U.S. Department  
of Transportation  
**Federal Highway  
Administration**

In Reply Refer To:  
HOTO-1

For recordkeeping purposes, we have assigned the following official ruling number and title: “4(09)-21 (I) – Clarification of RRFB Flashing Pattern.” Please refer to this number in any future correspondence regarding this topic.

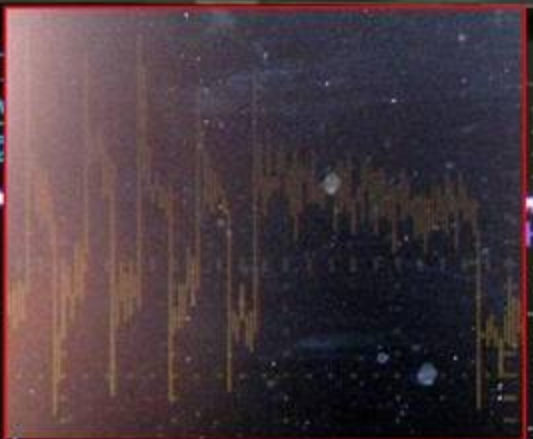
Scott: I have recently learned that the flash pattern we evaluated actually is two slow followed by four rapid flashes. Carl Morse has looked on a scope and the following is what has been determined: Each side of the LED flasher illuminated in a wig-wag sequence (left and then right). The left LED flashed two times in a slow volley each time it was energized (124 ms on and 76 ms off per flash) followed by the right LED, which flashed four times in a rapid volley when energized (25 ms on and 25 ms off per flash) and then a longer 200 ms flash. The total cycle length is 800 ms. The e-mail below from Rick Jones states that the units submitted to FDOT for testing had the same flash pattern as those evaluated in our research.

I have attached the scope tracing, and slow motion video of the flash pattern. Even in slow motion it appears like two slow flashes followed by three fast flashes but the eyes is deceived. This flash pattern is likely an SAE standard. Carl noted another LED flasher manufacture used the same pattern on flashers made for a different application. Since the 2/4 pattern is what we evaluated, and is what is manufactured, it is my recommendation that the standard be changed to reflect this. Thanks, Ron
